APPENDIX C: AGENCY RESPONSES TO SOV LETTER

- U.S. Army Corps of Engineers – 11/2/2023
- U.S. Fish and Wildlife Service – 10/31/2023
- USDA Natural Resources Conservation Service – 11/7/2023
- Minot Air Force Base – 11/1/2023
- North Dakota Game and Fish Department – 11/24/2023
- North Dakota Department of Environmental Quality 11/7/2023
- North Dakota Department of Water Resources – 11/17/2023
- North Dakota Parks and Recreation Department – 12/8/2023
- North Dakota Geological Survey – 10/31/2023
- Mountrail County Division of Emergency Services – 11/1/2023
- Mountrail County Planning & Zoning – 10/31/2023
- Mountrail County Department of Roads & Bridges – 11/15/2023
- Montana-Dakota Utilities Co. / WBI Energy – 10/31/2023

STANLEY MUNICIPAL AIRPORT STANLEY, ND

FIGURE 3-3

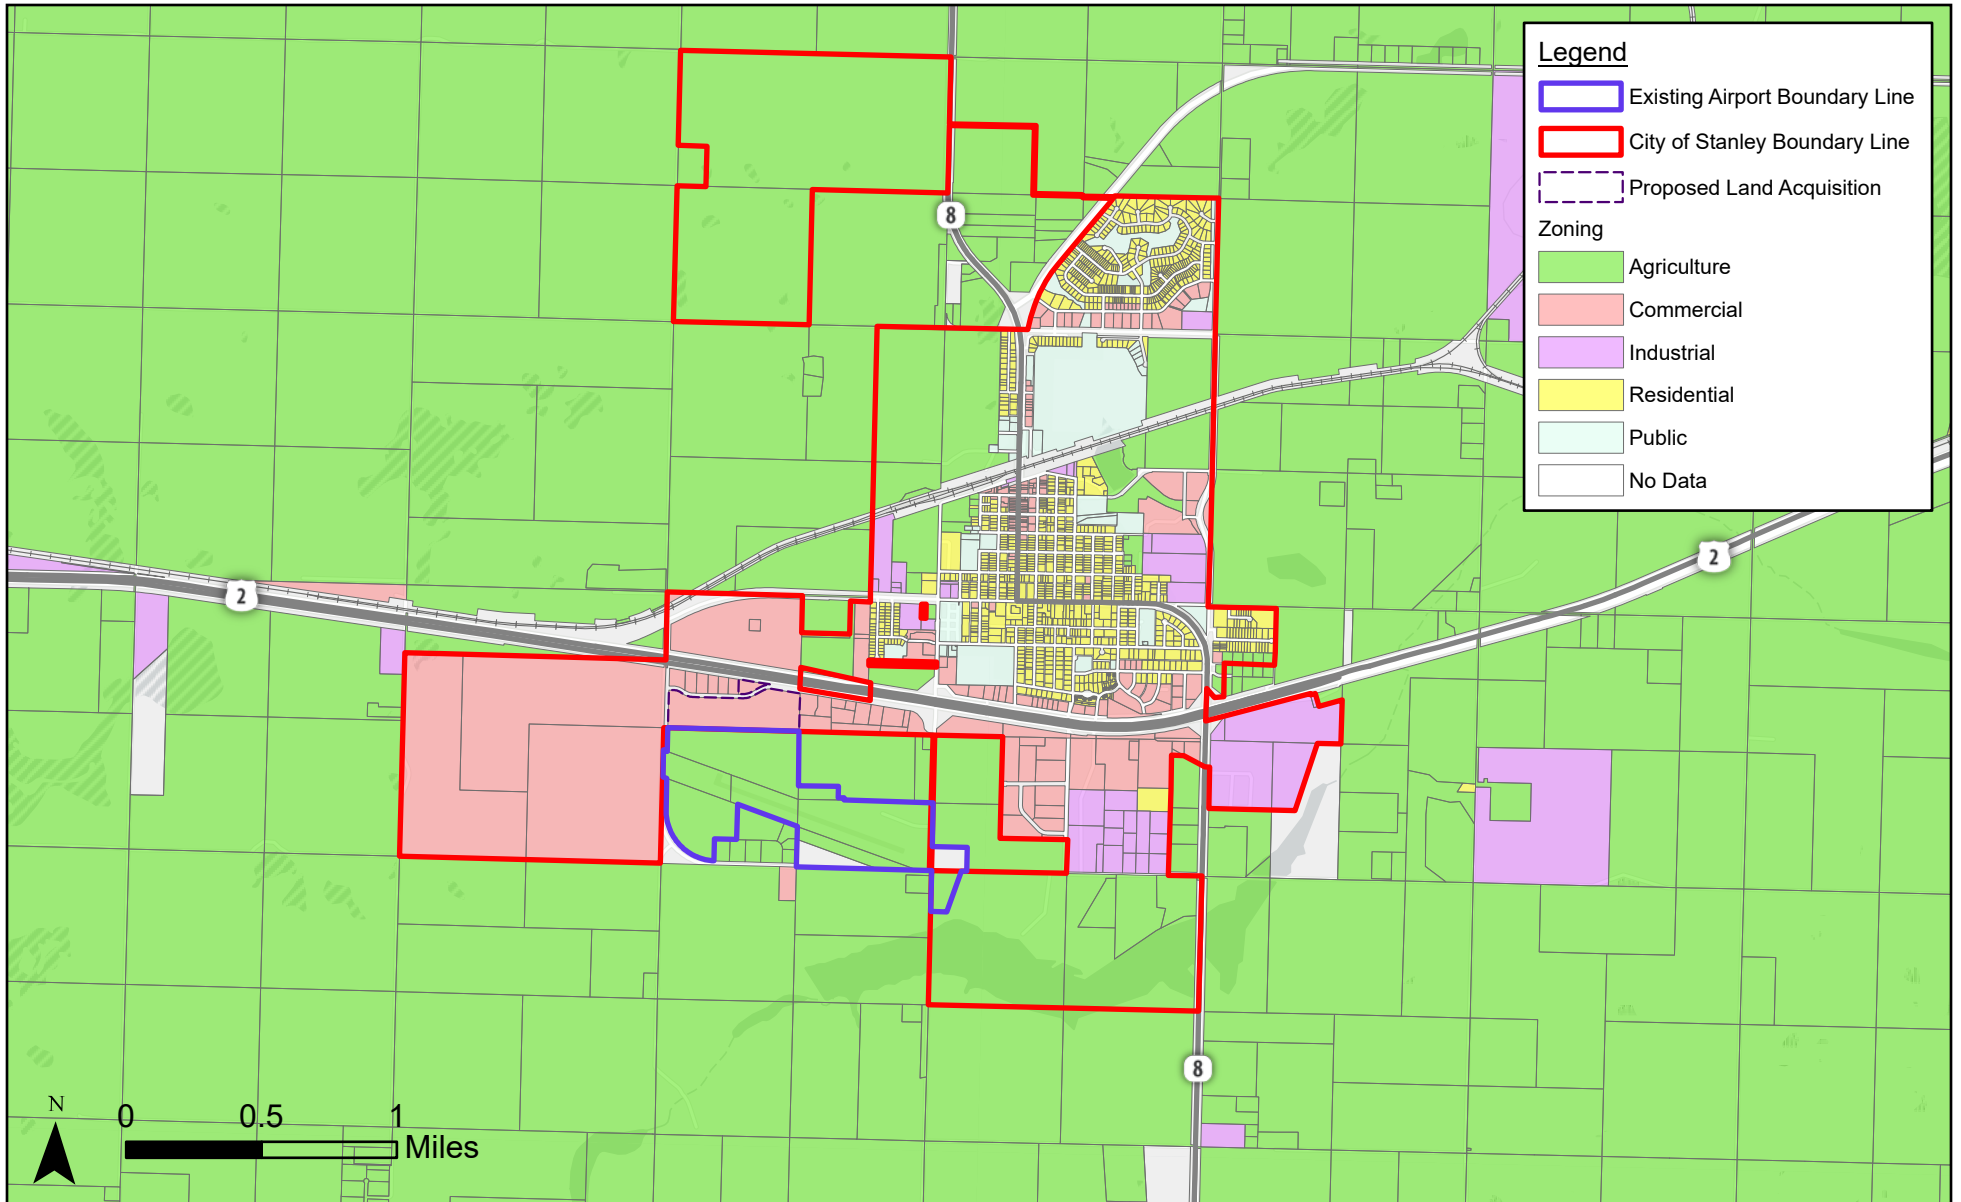
Thank you for providing comments (1st attachment) on the proposed project to construct a turf crosswind runway at Stanley Municipal Airport. In consultation with the FAA and after reviewing the proposed project area in relation to FPPA requirements, we believe that the Airport property and proposed land acquisition are not subject to the provisions of the FPPA for the following reasons:

1. The existing Airport property is exempt because construction of the proposed project will occur within an existing right-of-way purchased on or before August 4, 1984. The existing Airport property was purchased in 1970.
2. The proposed land acquisition is exempt because the parcel is situated entirely within an urbanized area (the City of Stanley) – see 2nd attachment for zoning map.

As previously stated, NRCS has a major responsibility with the Farmland Protection Policy Act (FPPA) in documenting conversion of farmland (i.e., Prime, Statewide Importance and/or Local Importance) to non-agricultural use when federal funding is used. With the new information you provided, NRCS is revising its letter dated November 7, 2023. The Turf Crosswind Runway project is within the city limits of Stanley, North Dakota where FPPA does not apply; therefore, no further action is needed.

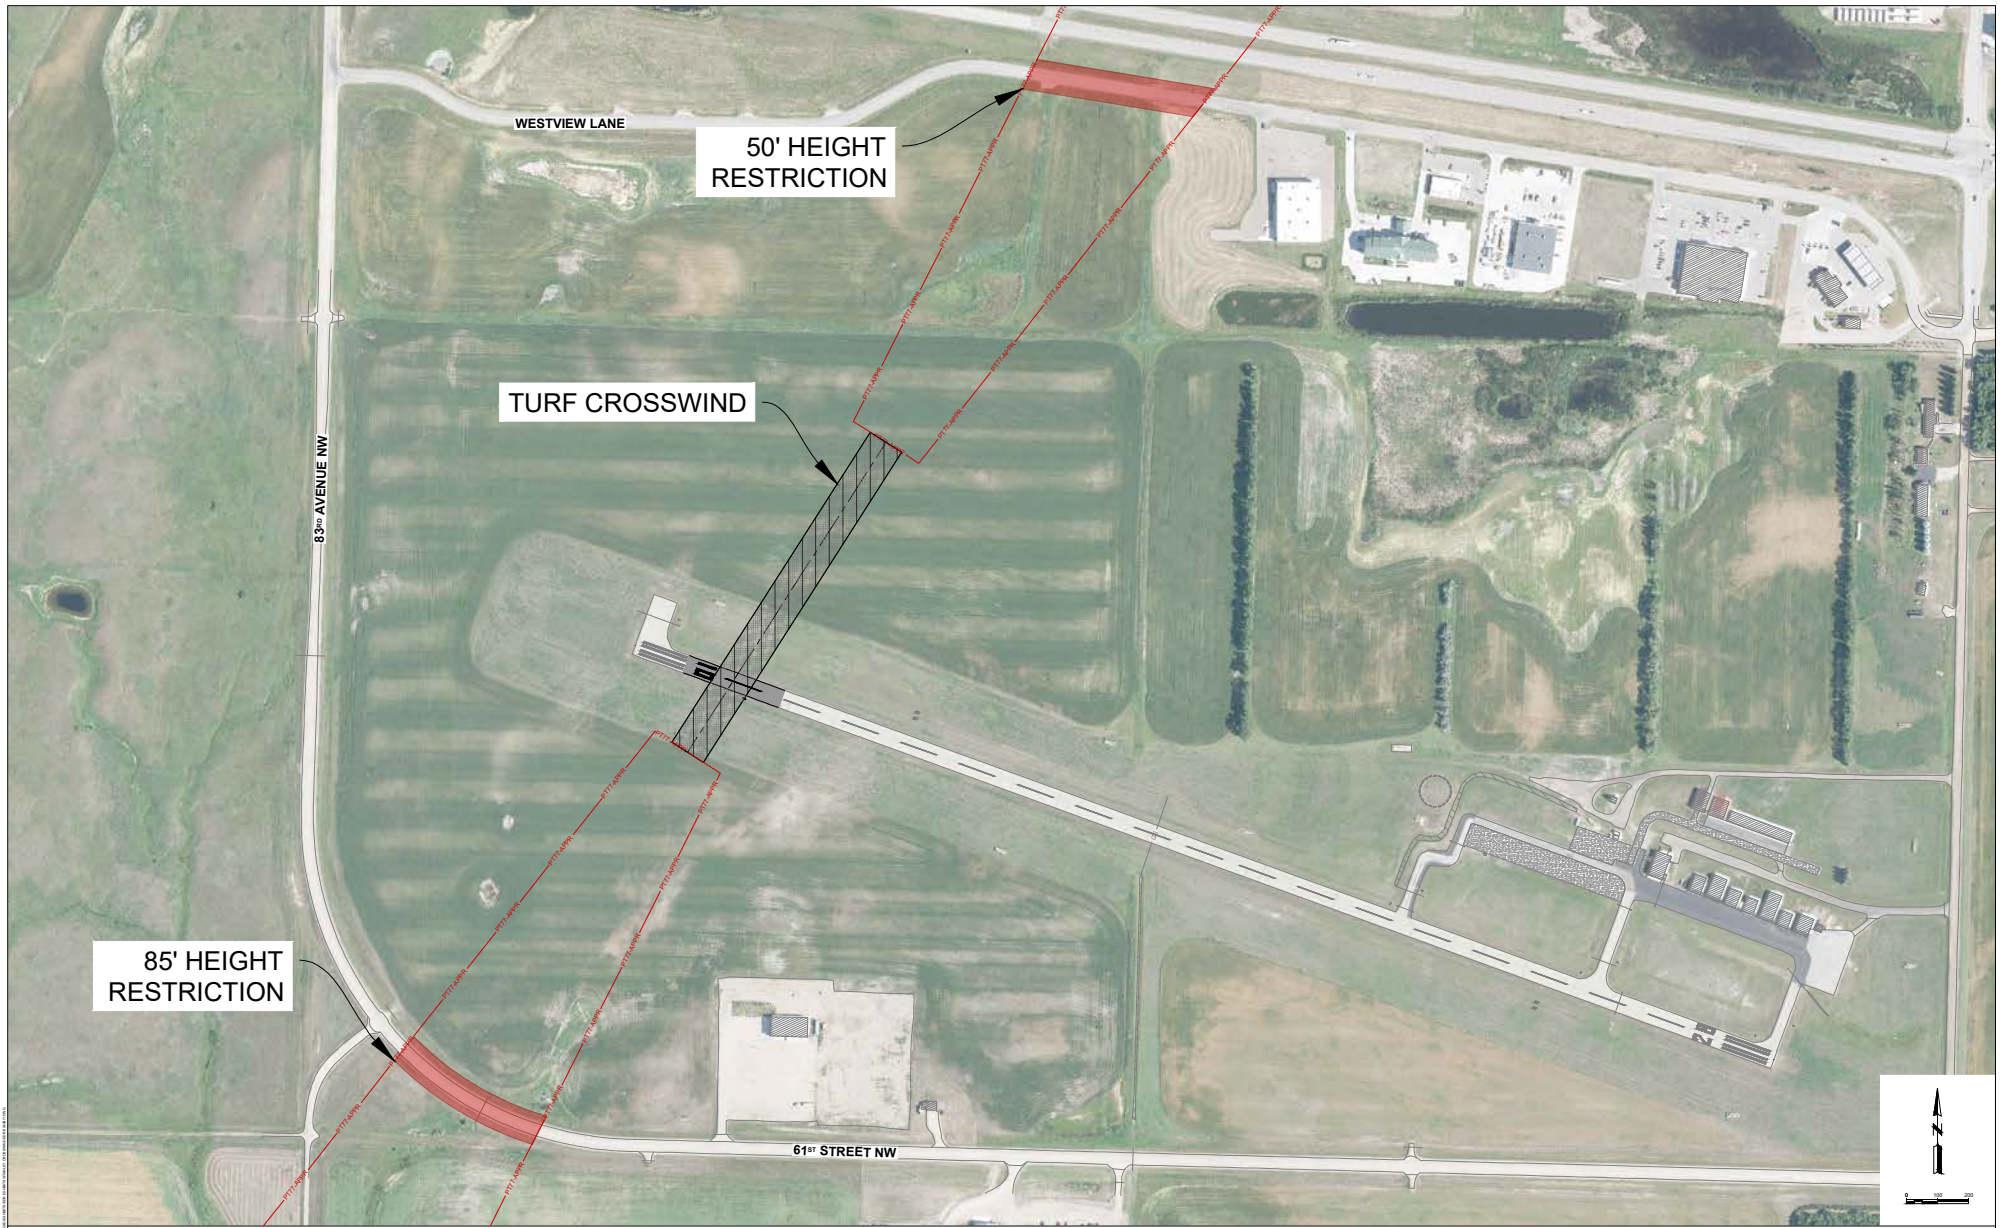
Our Board of Mountrail County Commissioners would like you to define “meaningful impact”. They would like to know if there will be or won’t be any future restrictions (questions #2 and #3). If there will be future restrictions, can you please elaborate on that topic and provide a detailed explanation.

See the attached exhibit.

3. Future roadway improvements – will there be any additional restrictions regarding access or infrastructure improvements due to this new runway, as the airport is adjacent to our roadway.
No impacts from this project.
